**NORTHERN PASS
TRANSMISSION LINE PROJECT
ENVIRONMENTAL IMPACT STATEMENT**

Volume 3: Appendix L. Comment Response Document

Attachment C.
Response to All Comments on the Draft EIS

Figure 1: the basis for the estimated decline in property values in the draft EIS
Adverse Impact of an HVDC Line on Residential Property Values, Results from the Literature

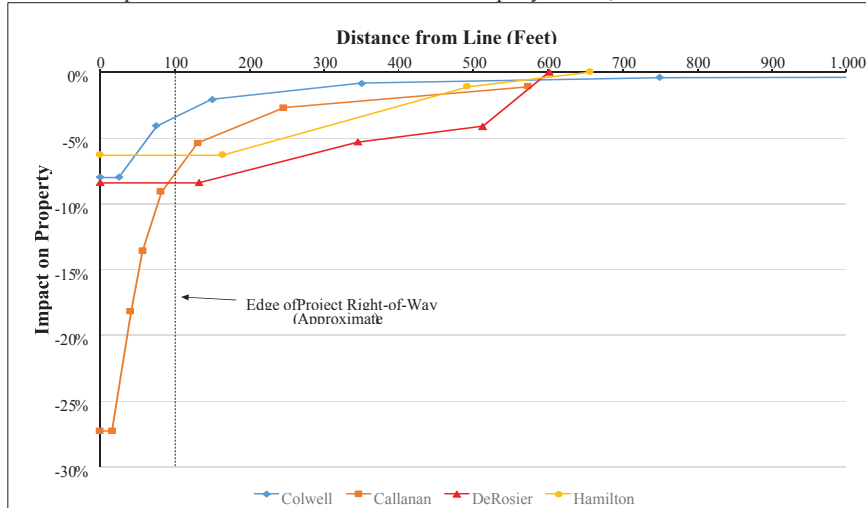
These two critical assumptions were based upon a literature review, not upon analysis of any properties that would be affected by the project. In fact, these two assumptions were based upon selected results from just four studies. These studies were selected because they used multiple regressions that included distance from the line as well as the usual housing characteristics that might be used by an appraisers. The results from the four studies were combined into Chart 4-1 in the draft EIS, which is reproduced here as Figure 1.

In the draft EIS's Chart 4-1 (see Figure 1 above), this study is summarized by a line connecting four points shown in Table 2. The percentages are the same 6.3%, 6.3%, 1.1%, and 0% figures reported by Hamilton and Schwann, but the percentages are improperly connected to distance. The paper indeed shows a 6.3% decline in property values for properties adjacent to the line as compared to the properties if they were located 100m (330 ft.) from the line. Likewise, the paper does show a 1.1% decline for Mid-Range properties if they were located 200m from the line, but these properties were actually located an average of 170m from the line. Thus, the 1.1% increase in value would reflect an average an increase in distance of only 30m. The paper does not report the average distance from the line for the Adjacent Properties, nor does it show an increase in value for increasing values if Adjacent Properties were moved from locations 100m away to locations 170m away (i.e. to the average distance for the Mid-Range Properties). In other words, the results reported by Hamilton and Schwann do not directly translate into a curve that would properly fit into Chart 4-1 in the draft EIS.

Chart 4-1 in the draft EIS shows a line purporting to show the results of the Des Rosiers study. The five points in this graph bear little or no relationship to Des Rosiers's own conclusions (Table 5). Des Rosiers concludes that the average loss in value is 10% within 500 feet of the easement boundary, which would be about 600 feet of the centerline of the transmission towers. This average loss in value is three times greater than the 3.5% loss of value that the draft EIS uses based upon Chart 4-1.

Thank you for your comment. Section 4.1.2 of the EIS addresses the anticipated impacts of the Project on adjacent properties, property values, and current/future tax assessments/payments. An exhaustive literature evaluation was undertaken to identify peer-reviewed studies which specifically assessed the potential impact of transmissions lines on adjacent real estate values. This information is presented in the Socioeconomic Technical Resource Report for the final EIS and in the EIS (Section 4.1.2). As a result of comments on the methodology and assumptions provided on the draft EIS, adjustments to the original analysis have now been updated in the final EIS. As these details are far too complex to be summarized within this response, the commenter is referred to both the Socioeconomic Technical Resource Report for the final EIS, and Section 4.1.2 of the final EIS.

Figure 1 The power lines are clearly visible where Crane Hill, Blake and Jesseman Roads meet at a point on a hillside overlooking fields with a view toward Garnet Hill. (Source of map: White Mountains Region, draft Project Area Form, Section 106 Research for the Northern Pass Project, June 2015)

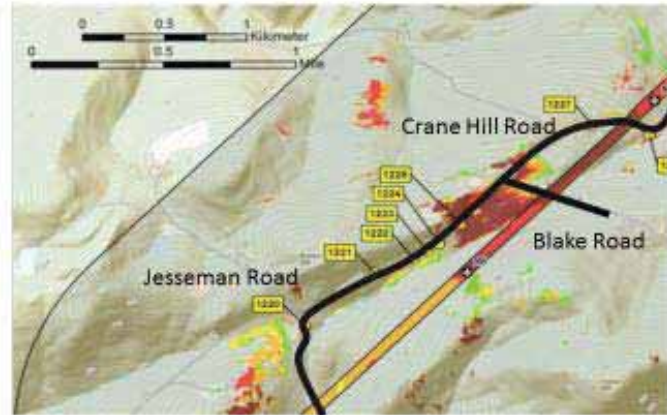
The existing powers lines are clearly visible from hillsides across open fields in only one portion of Sugar Hill that includes the southern end of Crane Hill Road, the northern end of Jesseman Road, and the western end of Blake Road. Figure 1 shows the location of these roads in relation to the power lines. The underlying map shows the visual impact of the steel towers originally proposed by Northern Pass along this right-of-way. The number of structures that would be visible from each location are color-coded in the map, which was prepared by consultants to US DOE as part of the Section 106 Historical Review Process for the Northern Pass Project. Areas of deep red, such as those along the three roads highlighted on the map, would have more than 40 towers visible. Areas that lack color, such as the northern portion of Crane Hill Road, the eastern portion of Blake Road, and the southern portion of Jesseman Road, are forested and therefore would have no views of either the existing wooden poles or the proposed towers. The numbered yellow markers locate old houses and barns identified by the DOE consultants as having potential historic importance. Examination of town records and USGS maps of this area indicate that:

located on new town or private roads close to the PSNH ROW.⁴ Essentially all of these new houses and residential lots would have views adversely affected by the steel towers originally proposed by Northern Pass.

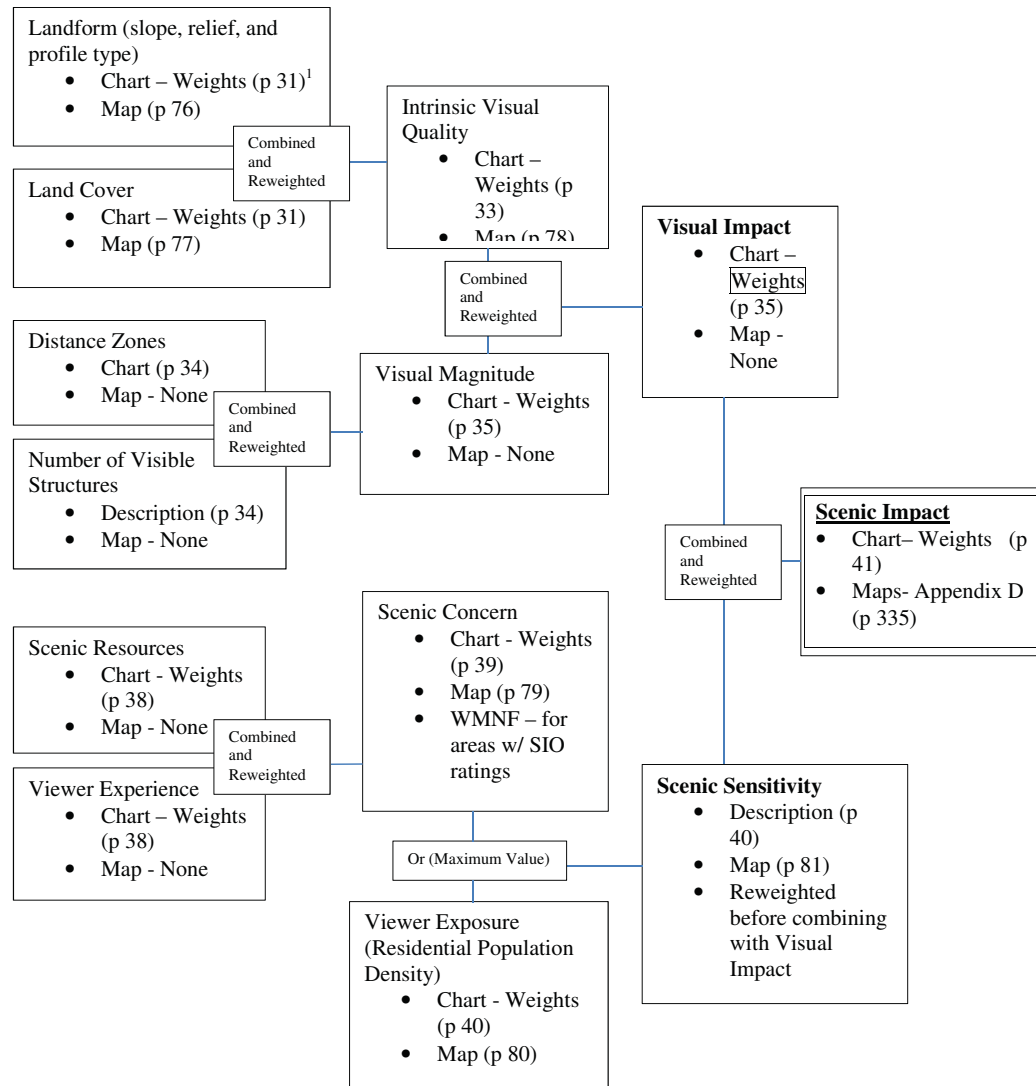
With this scheme, more nonsensical results occur, e.g. Figure 10 in the Visual Assessment Technical Report shows zero “Scenic Concern” for most of the Northern Region. Until the flawed data inputted into this matrix are corrected, the results of Table 7, Figure 10, etc. are without merit.

The results (i.e. Visual Impact Assessment Technical Report, Figure 10) show the Northern Region to have “very low” to “no” potential viewer exposure due to low US census data. This is counter intuitive for multiple reasons. Areas ranked as having a natural landscape in the “Visual Impact” component of this analysis invariably have a low US Census count, otherwise they would not be natural in appearance and would be less visually desirable. For example, this means the White Mountain National Forest, Yellowstone National Park, or the North Region of this study area, all of which have minimal to no US census tabulated residences, would be ranked as having ‘low’ to ‘none’ potential for visual exposure. Yet these same locations are advertised for this very attribute of low population density, and are sought out by millions of tourists and vacation home owners. The assumptions used in this scheme are illogical, without merit, and result in a gross underestimation of the overall “Scenic Impact” of the Project. The data used by the DEIS needs to be revised, and incorporate relevant resident and vacation home owners, and transient tourist visitation information.

Thank you for your comment. The EIS and Visual Impact Assessment Technical Report do not include a statistical description of the alternatives. The most recent project design information, including tower types and heights, was used for the analysis of all alternatives and is represented in the simulations and other analysis. Table 2-1 in the EIS has information on corridor length by alternative, and figures in Section 2.3 of the EIS depict the various towers proposed. Chapter 5 of the Visual Impact Assessment Technical Report contains a summarized table of visual impacts.

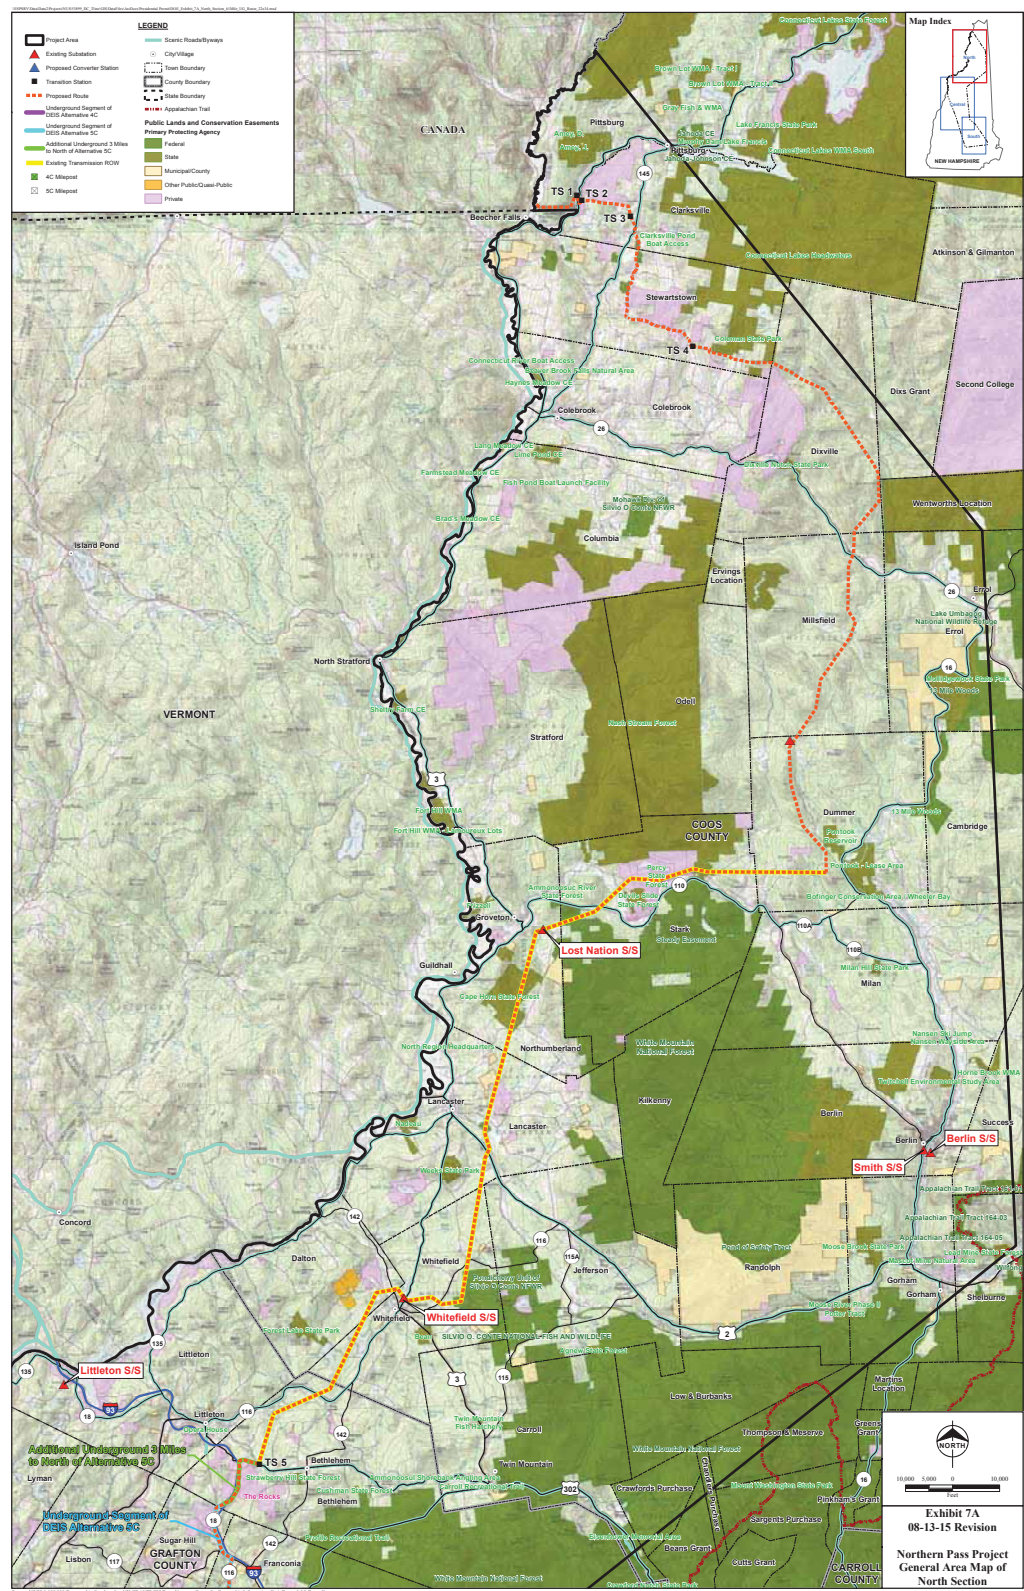
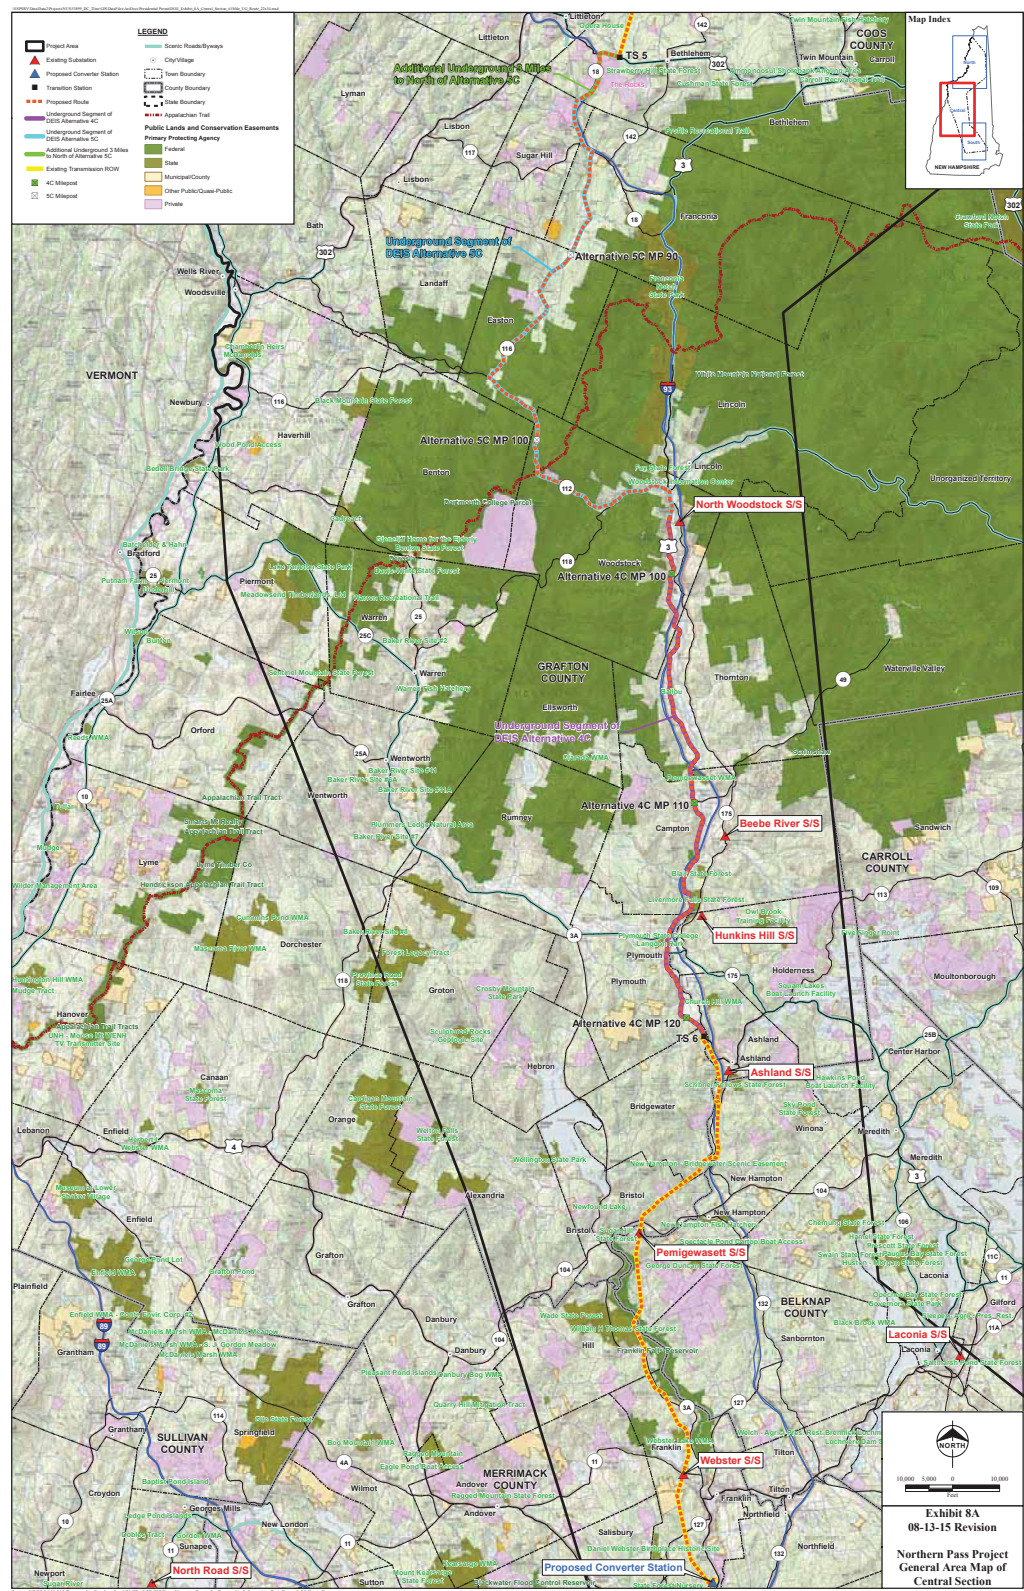
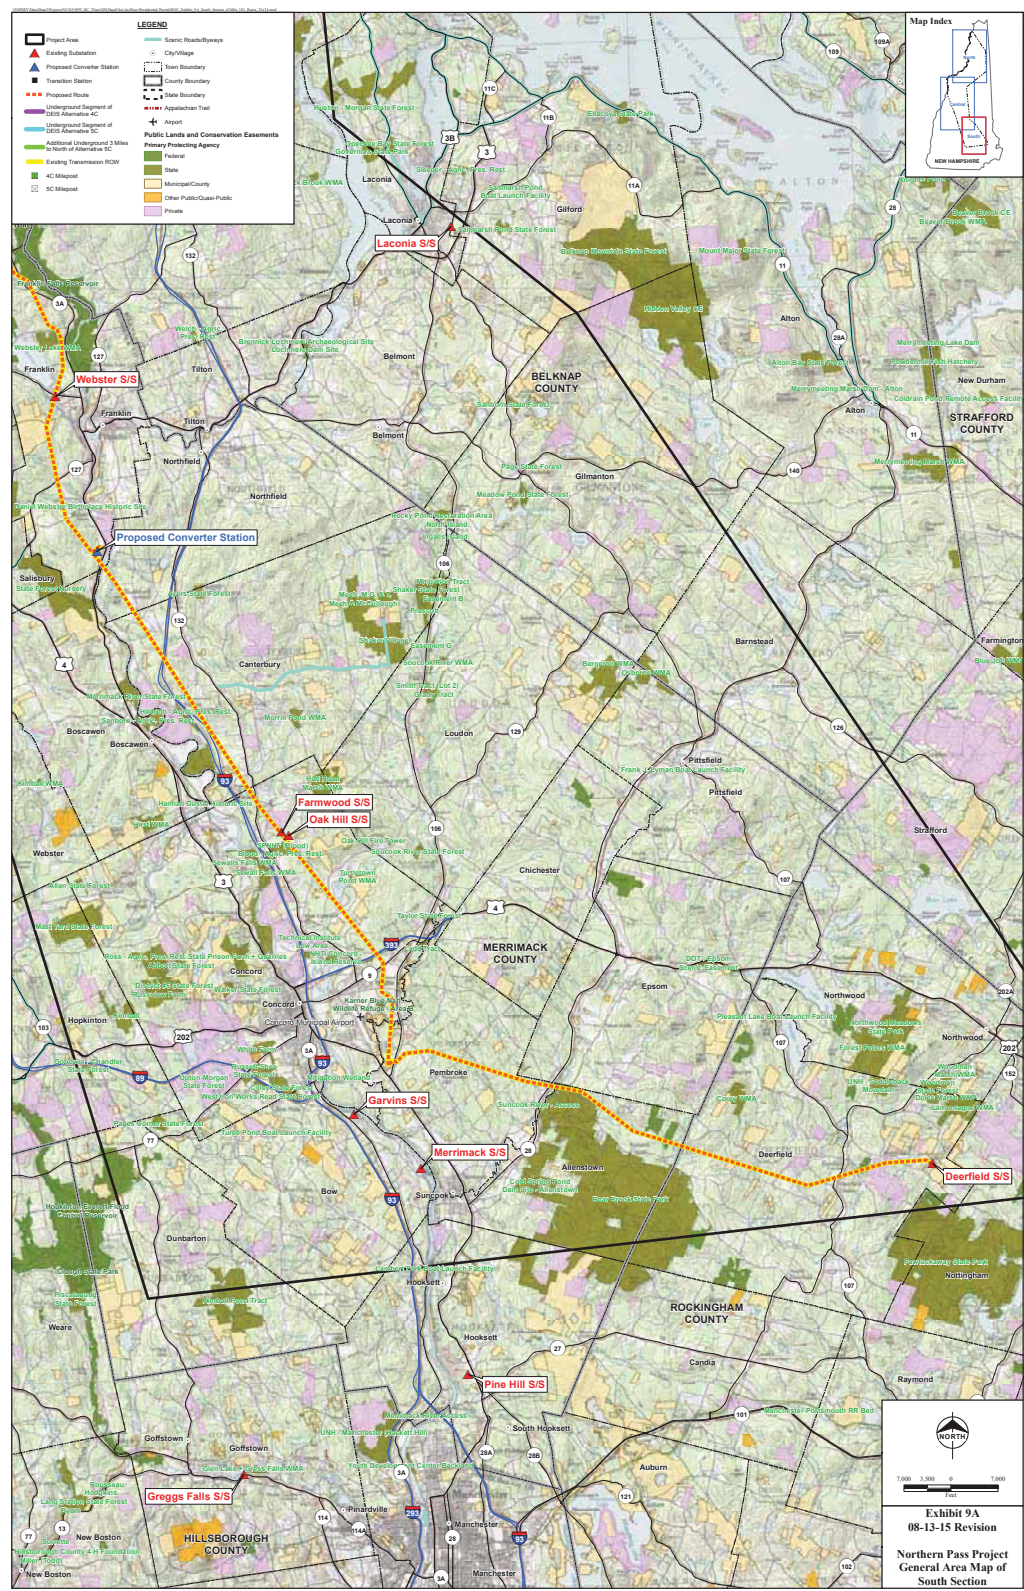
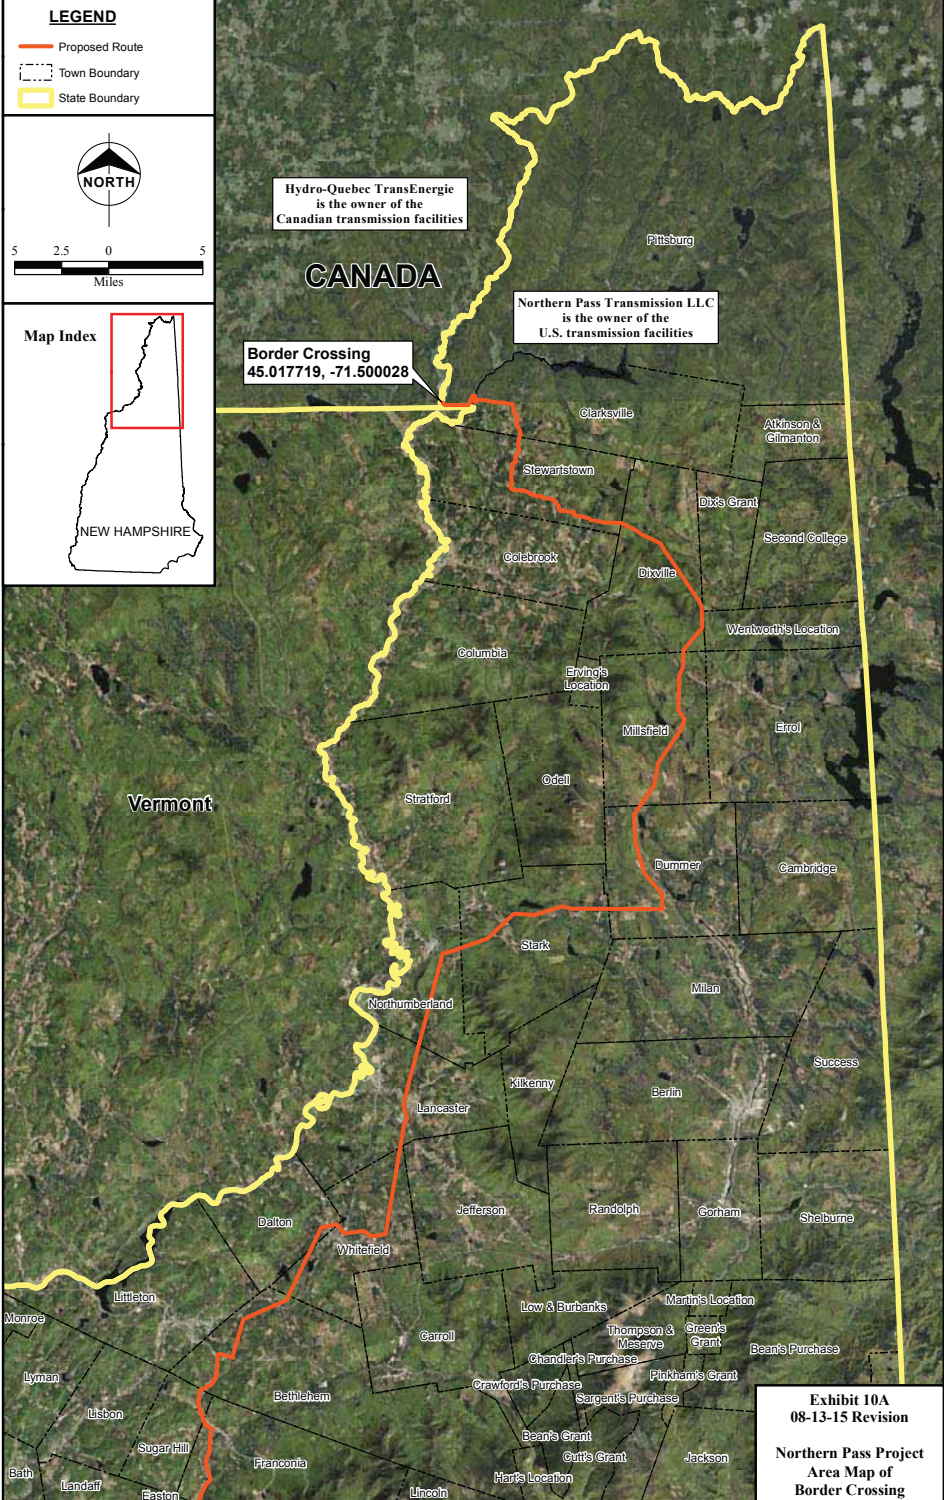
As the result of siting needs on the Canadian side of the border that have only recently emerged, the border crossing must move from Latitude 45.017820, Longitude -71.501217 to Latitude 45.017719, Longitude -71.500028, a distance of approximately 100 feet in an area that is similar in character throughout. This is reflected on the map shown in Exhibit 10A, a replacement for Exhibit 10 in the Amended Application. However, we note that the change is so modest that it is not visible at the scale of the map, which is the scale DOE regulations specify. The slight shift in the location of the border crossing will not require any change in location of the transmission structures, although a few structures will shift orientation.

Thank you for your comment. The final EIS has been updated to include a full analysis of the revised Proposed Action (Alternative 7), as presented in Northern Pass' Further Amendment to Presidential Permit Application received by DOE on August 31, 2015, and described in this comment.
